Accessories

E18401

Sensor Testpak

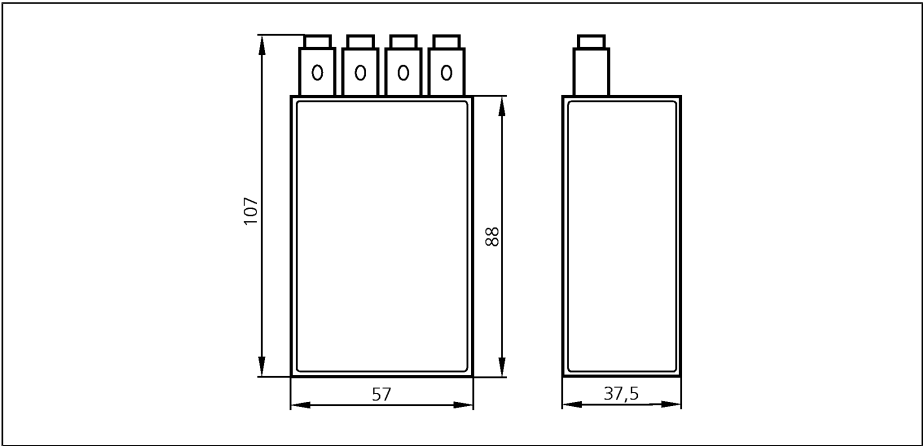
TestPak E18401 may no longer be available from IFM. This was replaced by E18430, however, this TestPak has proven to be unreliable to reprogram the IFM flow switch. The recommendation would be to replace the flow switch rather than reprogram the existing switch until a new TestPak can be developed by IFM Electronic.
